**Re: 2501 Gondola Way - Building Permit No. 87-2000**

# INSPECTION REPORT

**RENOVATION OF BUNBURY RESIDENCE**

**RENOVATION FOR THE BUNBURY RESIDENCE**  
DATE: JULY 16/87  
SHEET 1 OF 3

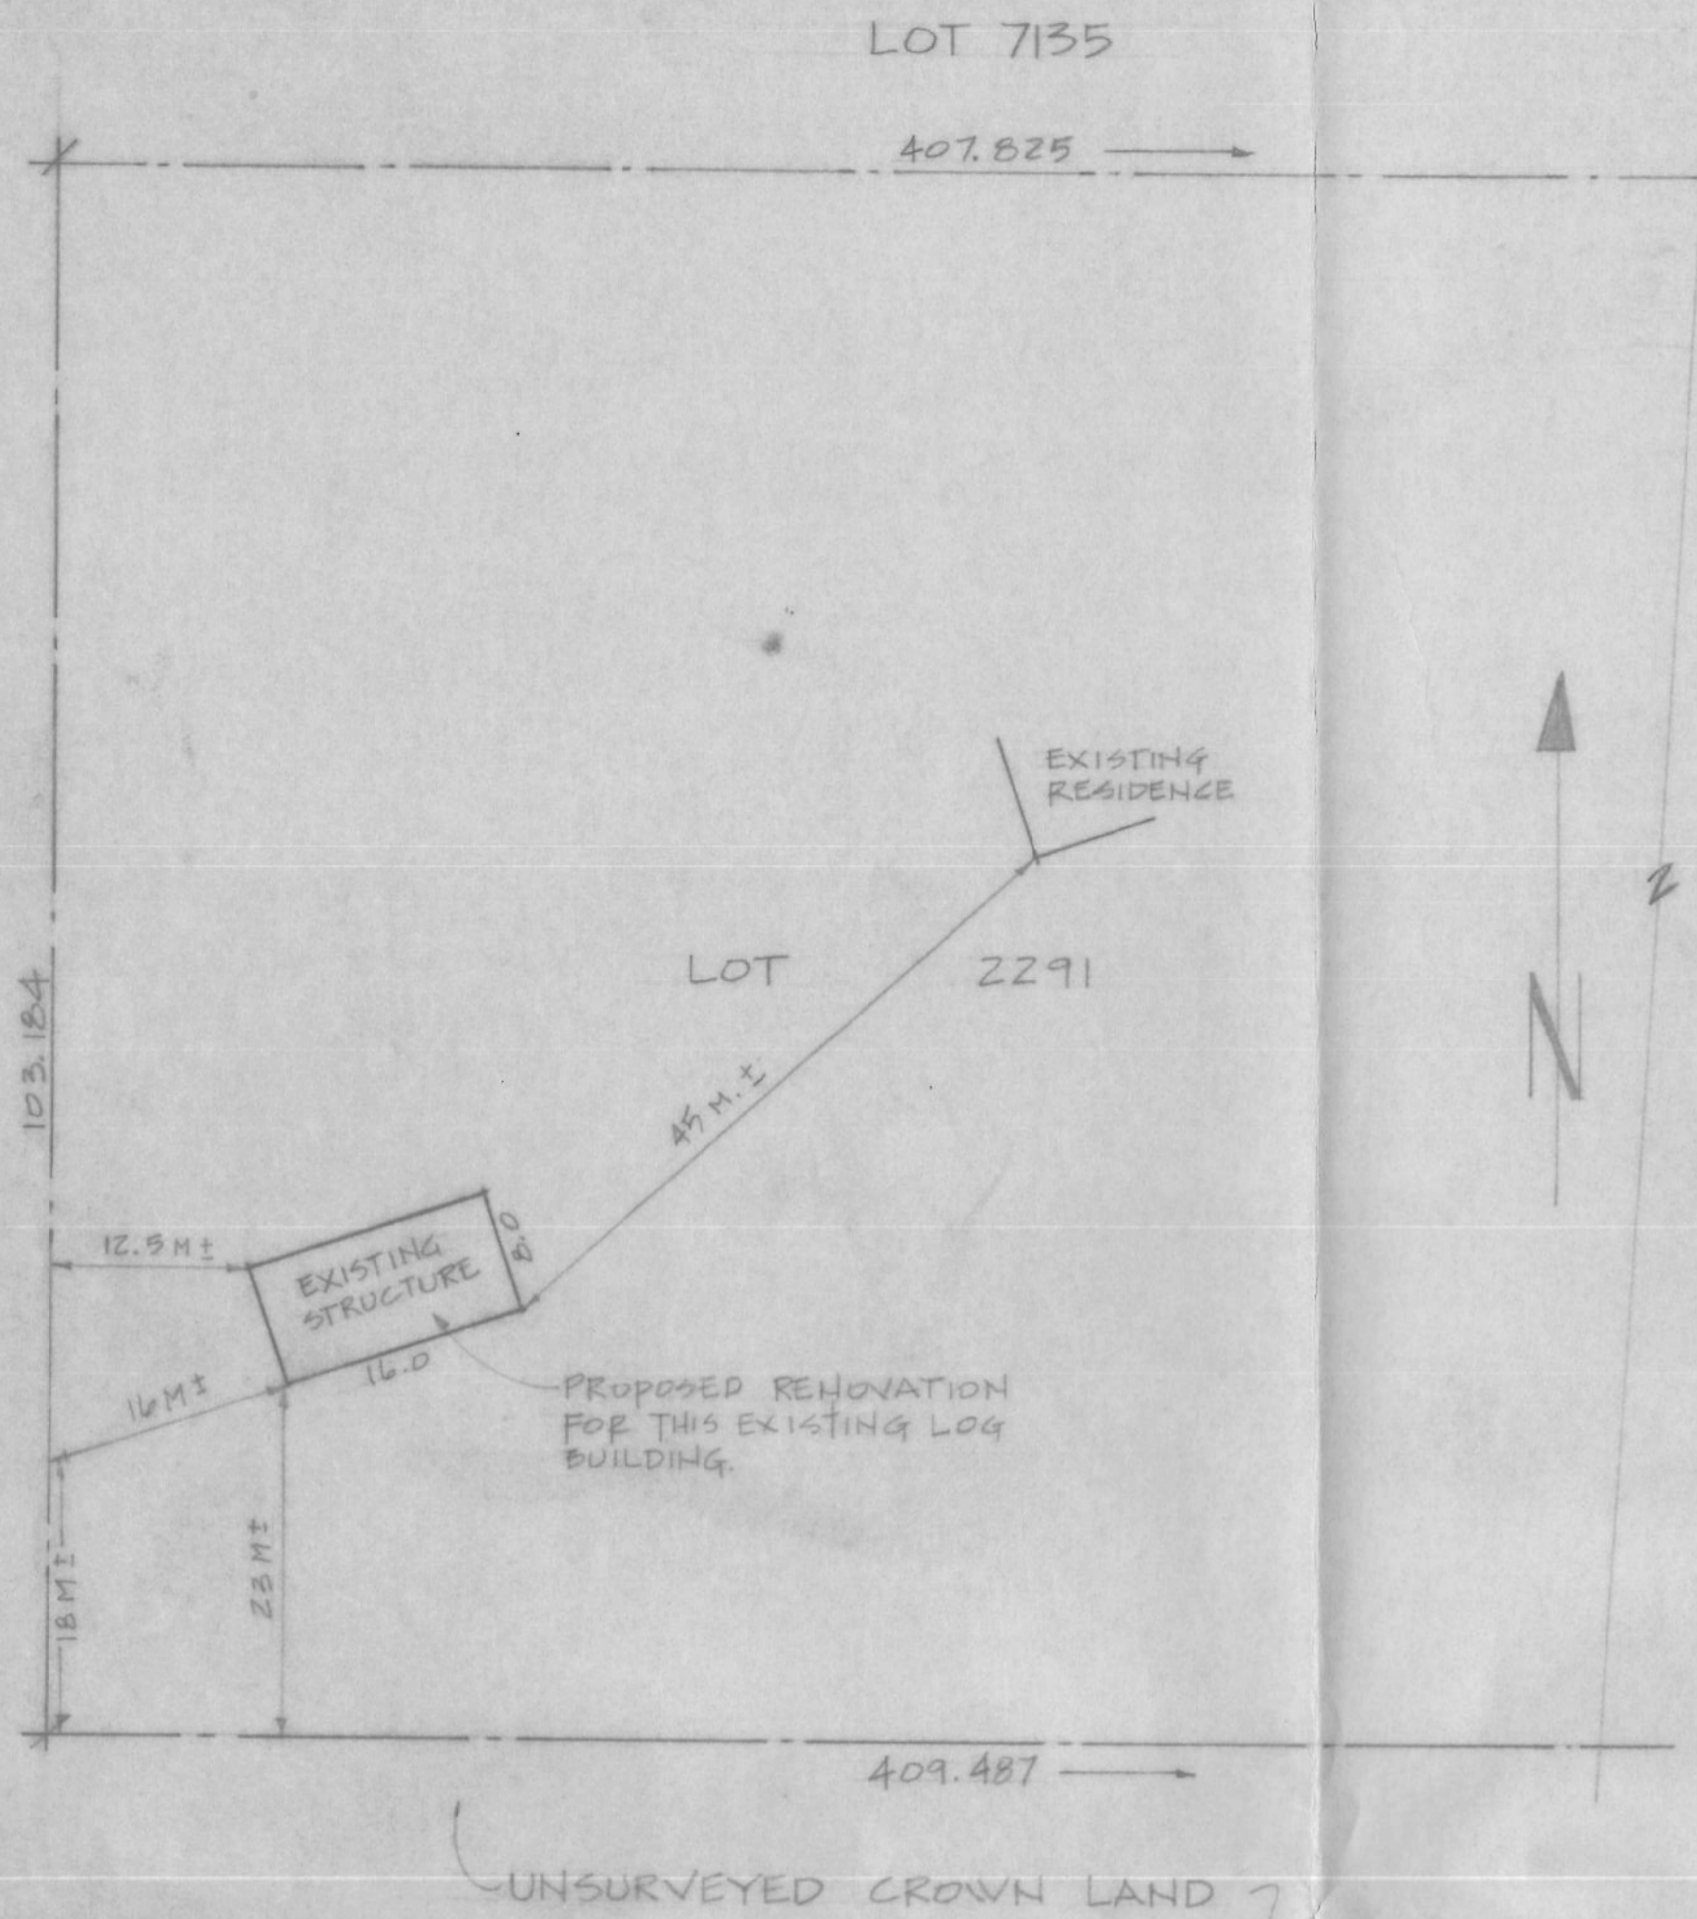
① THERE IS A 2x6 STUD WALL OVER THE EXISTING LOG @ THE DORMER. THE DRAWING SHOWS A 14" LOG. SOLUTION: SHEATH THE STUD WALL OVER ON THE LEFT SIDE, WITH 1/2" PLYWOOD GLUED AND NAILS SCREWED TO THE STUDS. ALL VERTICAL JOINTS ARE TO LINE UP WITH A STUD. NAIL @ 4" @ ALL EDGES.

② FOUNDATIONS WORK STILL TO BE DONE.
